SUBJECT: Responds to concerns raised during 891113-1204 insp re
 environmental qualification-terminal boxes & splices.

AEP:NRG:0775AQ

Donald C. Cook Nuclear Plant Units 1 and 2
Docket Nos. 50-315 and 50-316
License Nos. DPR-58 and DPR-74
ENVIRONMENTAL QUALIFICATION-TERMINAL BOXES AND SPLICES

December 20, 1989

FIG. 1: Wyle Test Report NEQ-45603-1

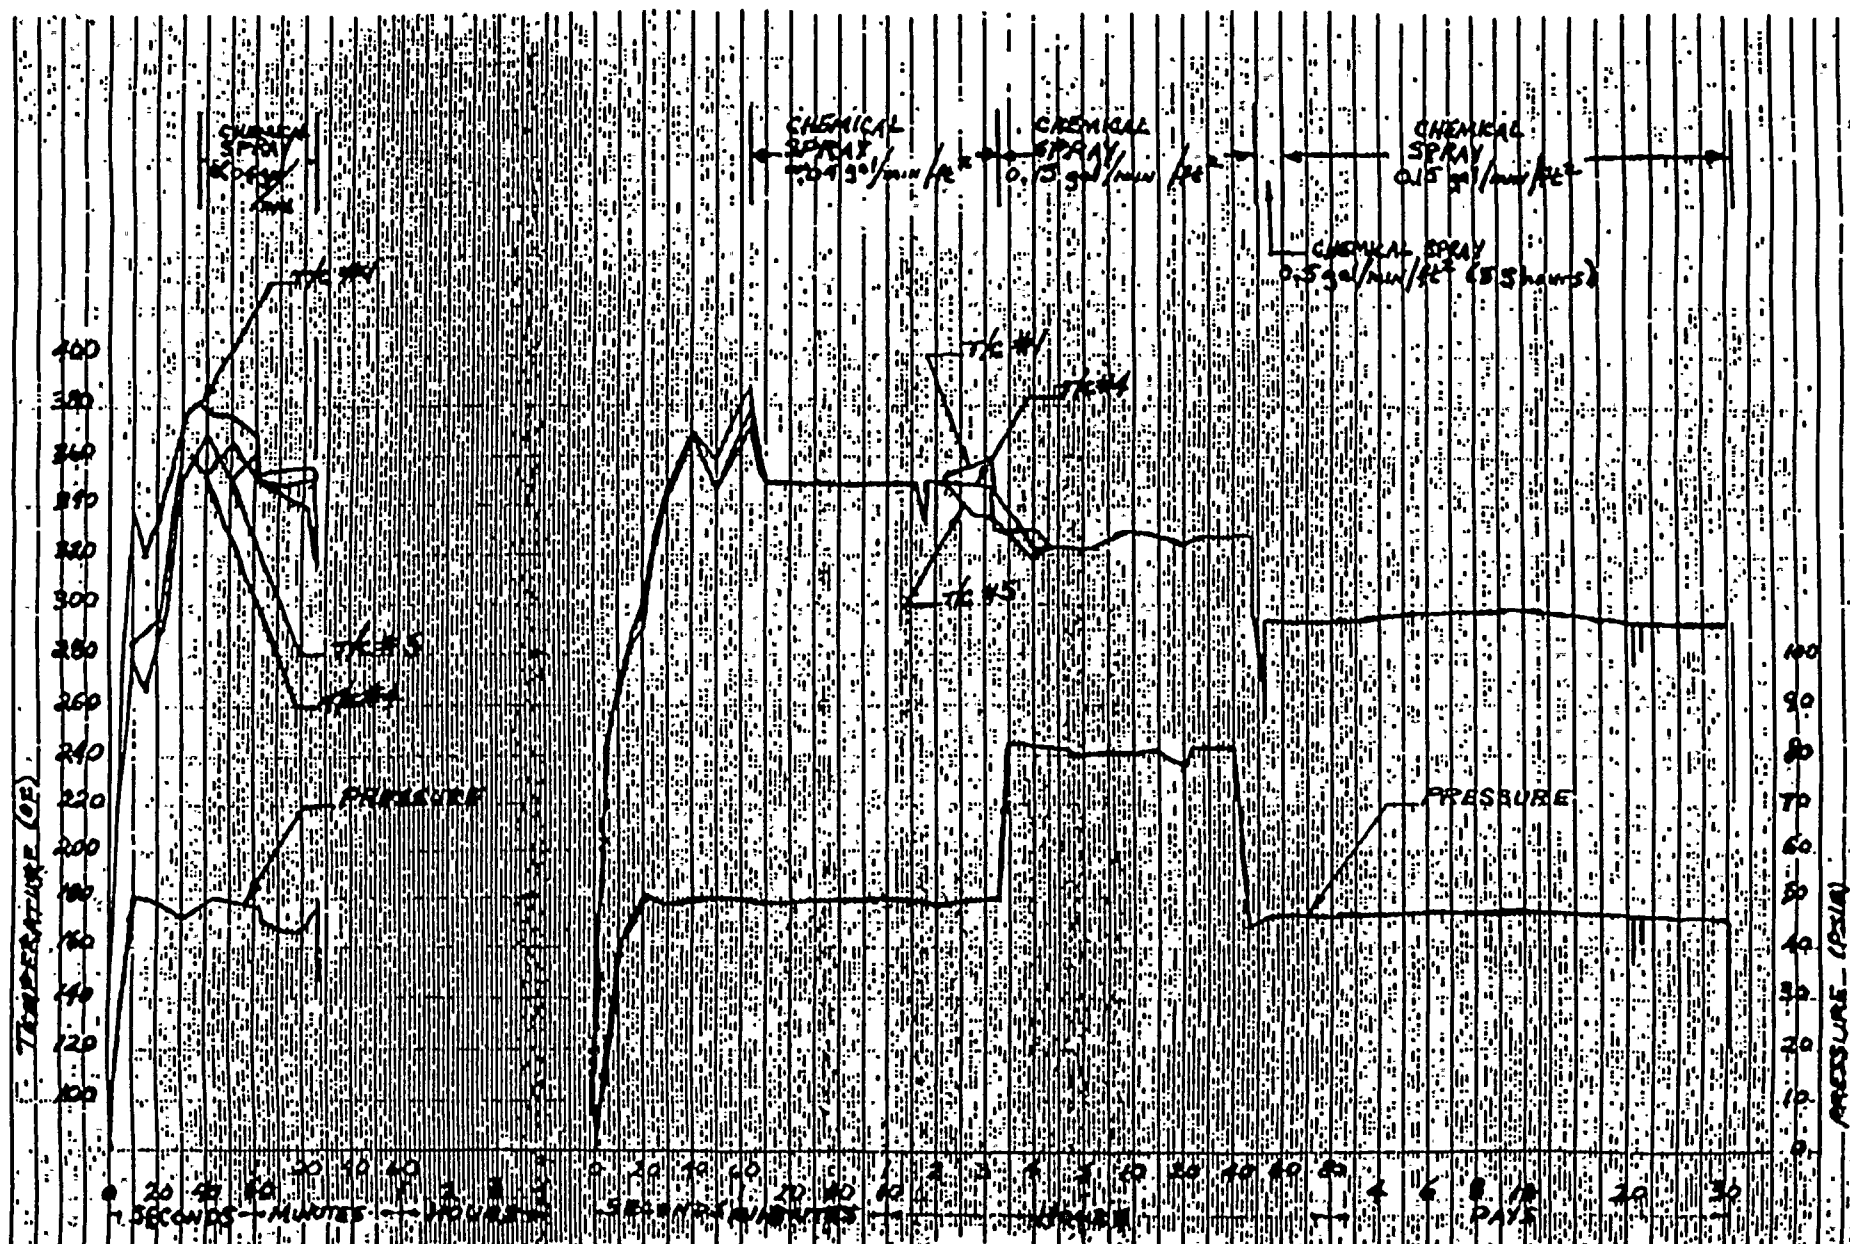
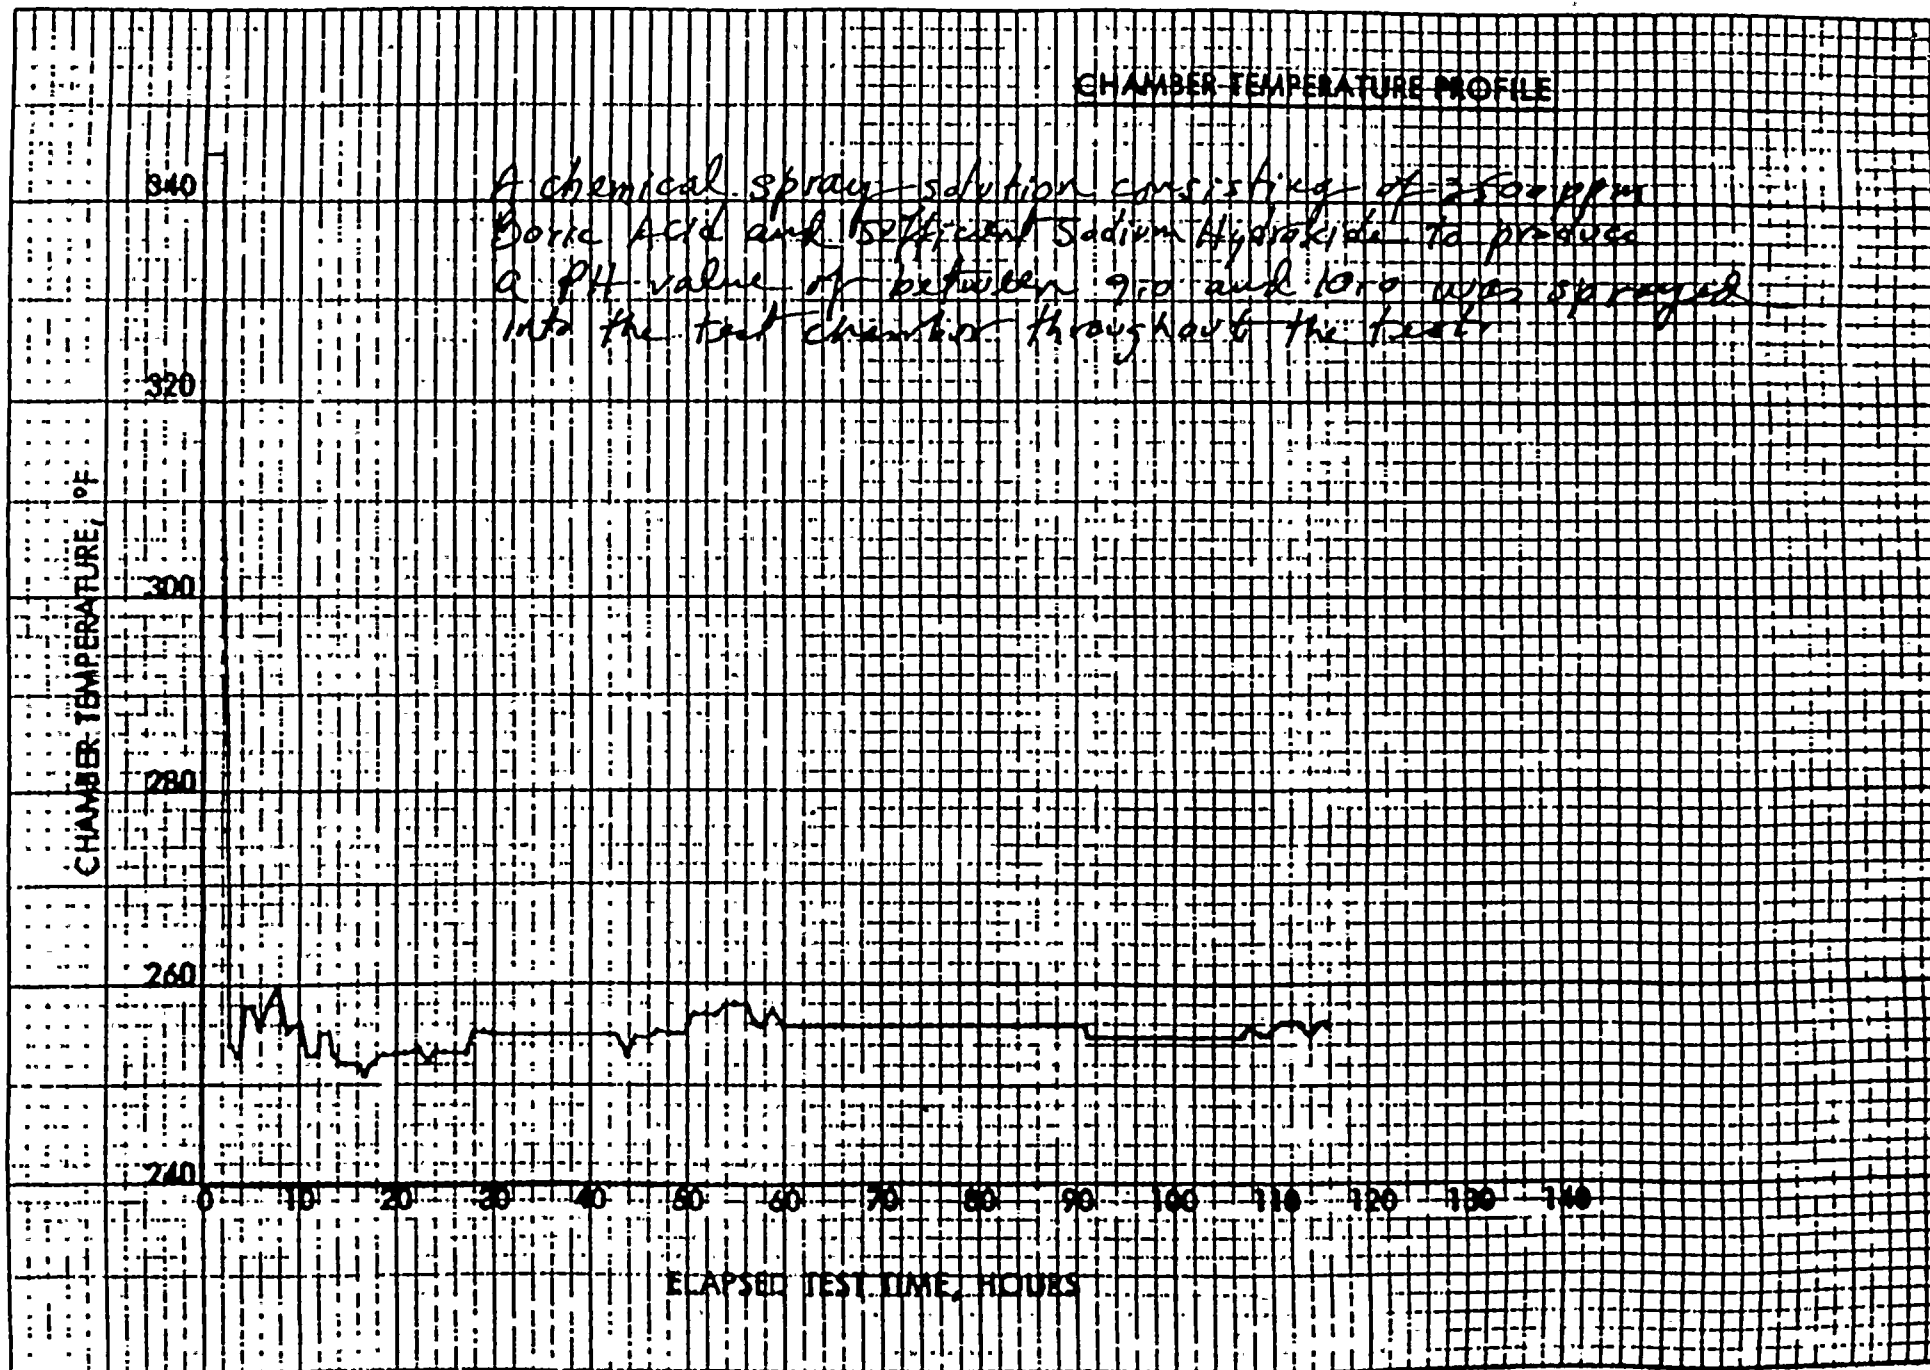
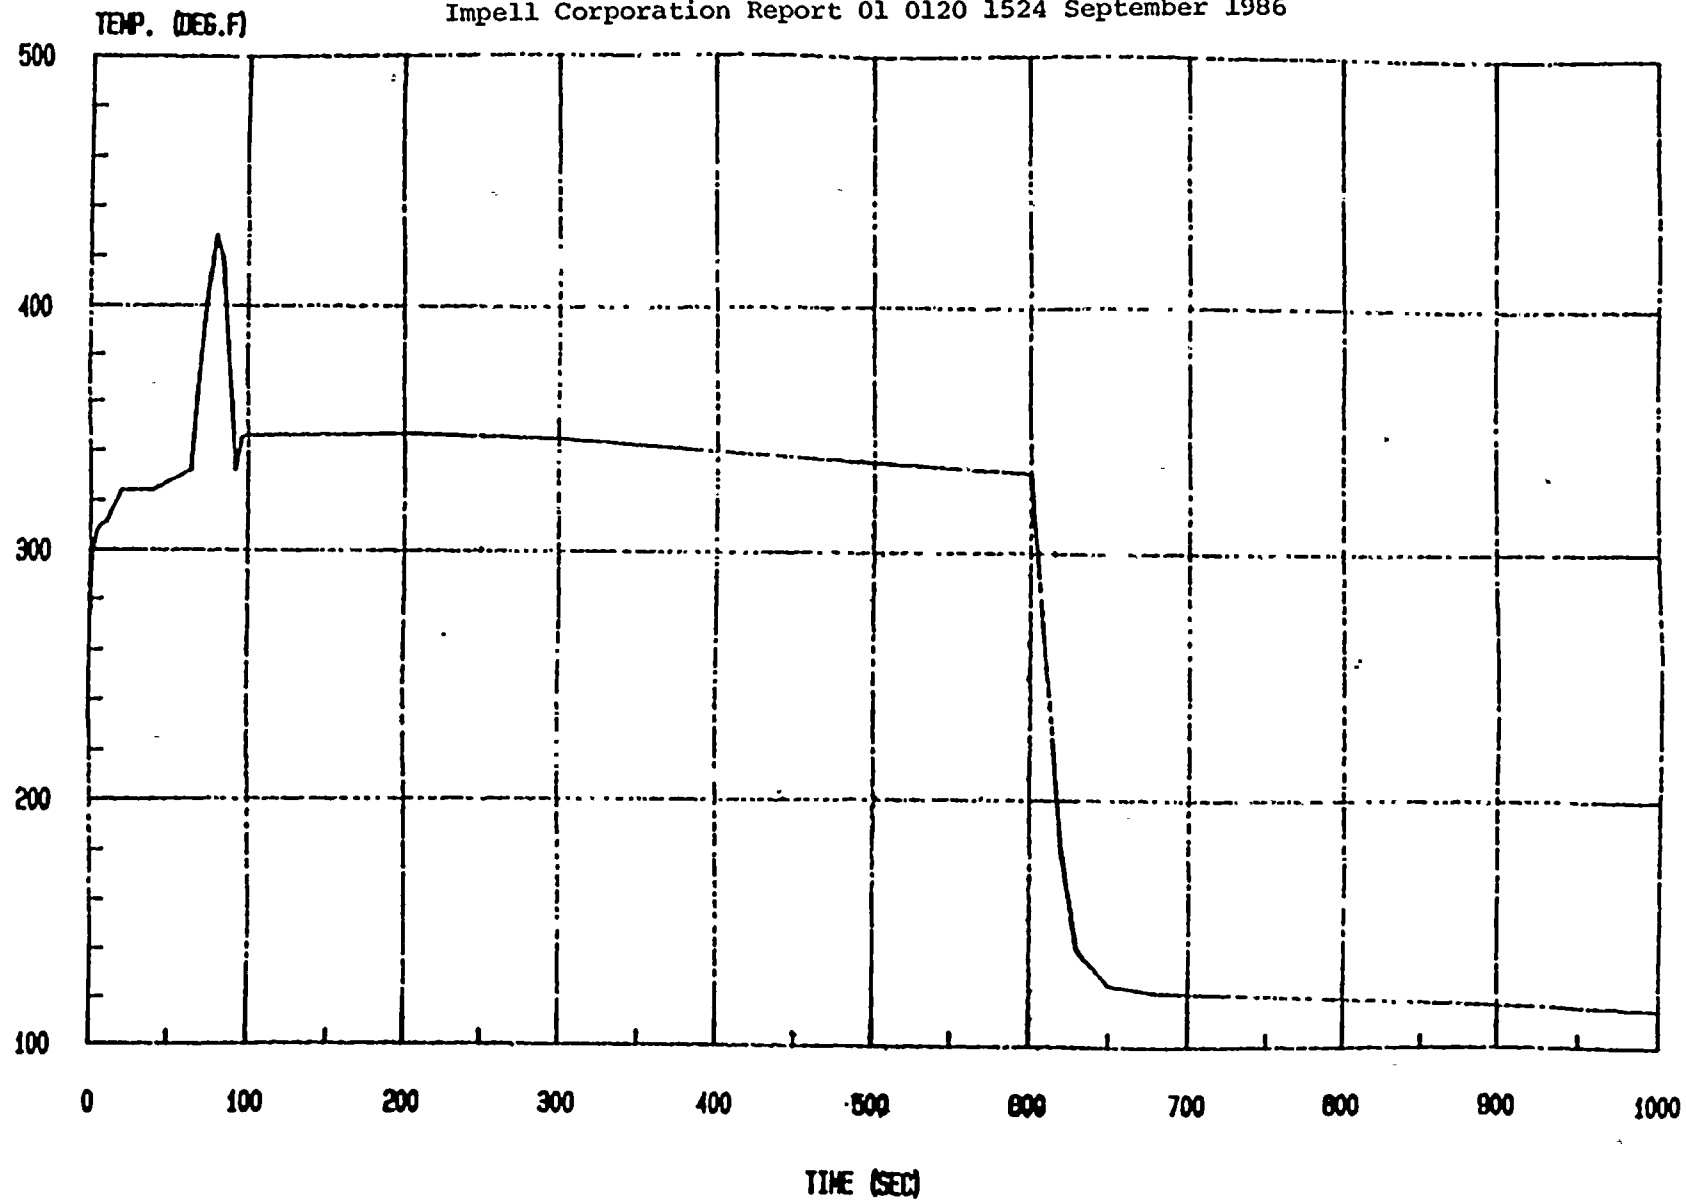
Cook Nuclear Plant following a postulated steam line break outside of containment. The test conditions for the Marathon test are given in Table 1, the test conditions for the Penn Union test are given in Table 2, and the profile for the postulated accident is given in Table 3. A comparison of the Marathon test configuration with the Cook Nuclear Plant configuration is given in Table 4. Figures 1 through 3 provide a temperature history for the test and the postulated accident.

It seems evident that during the 118 hours of the Conax test, more water spray and steam entered the terminal boxes and impacted the terminal blocks than is likely to happen following a 10-minute high energy line break (HELB) outside containment at Cook. Likewise, during the 30-day Wyle test, despite the use of a NEMA 4 enclosure, the weep holes in the enclosure and the open top entry conduit would allow steam and water spray to enter the enclosure. It is our opinion that the 30-day test subjected the terminal blocks to conditions more severe than would occur during a short duration (10-minute) steam line break.

The levels of margin present during these tests as compared with the postulated environments where the terminal blocks need to remain functional plus the foregoing discussion between the tested and installed configuration leads to the conclusion that the Cook Nuclear Plant terminal block installation, with top entry conduit and without terminal box weep holes, will remain functional following an outside containment HELB at Cook Nuclear Plant.

FIG. 4

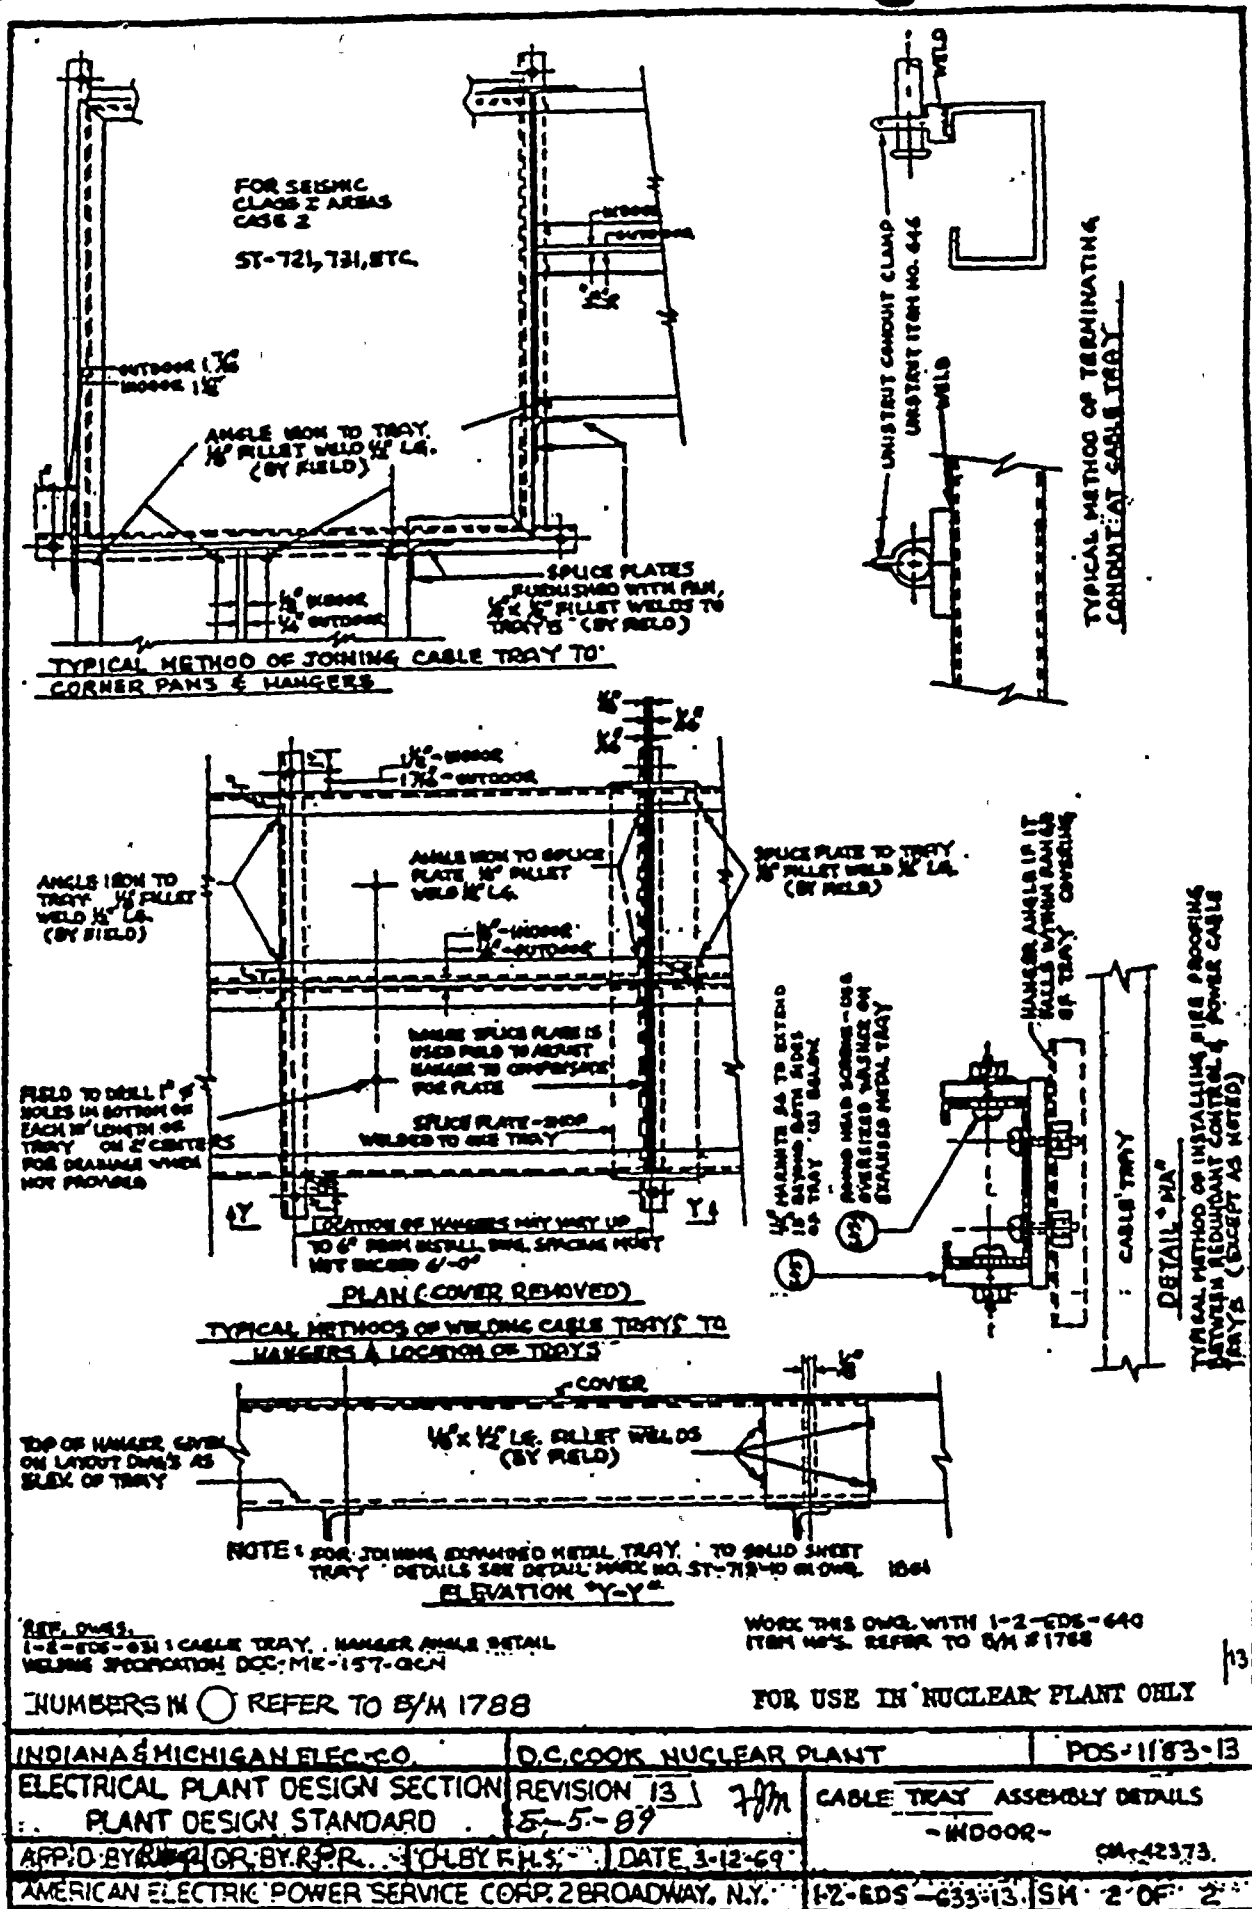
The question has been asked whether the conduit opening into a cable tray in a HELB area could serve as a channel for water running down through the conduit to the terminal box and shorting the terminal blocks.

The Cook Nuclear Plant design standards specify that "all Engineered Safeguards System and Reactor Protection System troughs require covers with the exception of the troughs installed in the Control Room Cable Vault" (Specification DCC-EE-605-QCN). PDS-1175 (Figure 4) requires one-inch holes every 2 ft. in the bottom of the cable trays for drainage purposes. Holes are stamped from inside out to eliminate any rough edges projecting inside the tray, and eliminating the possibility of water pooling in the tray. Further PDS-1183 (Figure 5) specifies conduit the cable tray horizontally at the top of the tray (the cables must be brought up from the tray and into the horizontal conduit).

From these specifications and standards, it can be seen that only steam (a gas) will be able to enter the conduit, but only during the 10 minutes outside containment DBE (Reference 3). On the

DWG # OP-2-98214-20

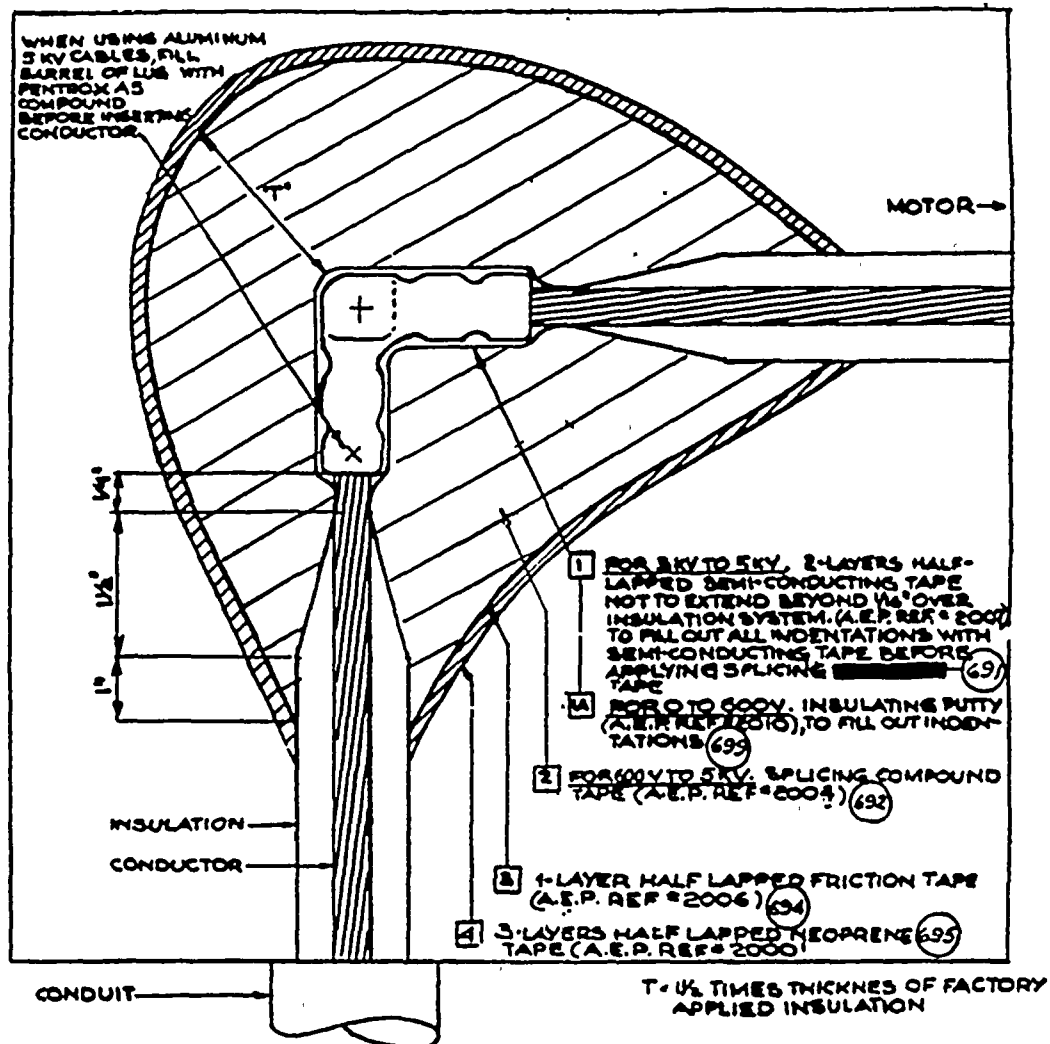
"On December 31, 1981 the fuses in the leakage current circuit of both remaining boxes were blown. The cause of the blown fuses was a voltage spike resulting from an abrupt reapplication of facility power, which had been off for approximately 15 minutes."

1. The valve actuator control circuits at Cook Nuclear Plant (Figure 6) (the EQ application for Marathon 1600 series) are not fused.

The control circuit (220 VAC) is fed from a 600 VAC power circuit through a low power control transformer (see attached control circuit schematic, typical). A momentary disturbance (voltage spike) in the control circuit will not generate enough current to trip the 600 VAC circuit protective device (circuit breaker).

For both the above reasons, we consider this anomaly (#6) to have no impact on the environmental qualification of the Marathon 1600 series terminal blocks for outside containment control circuit applications at Cook Nuclear Plant.
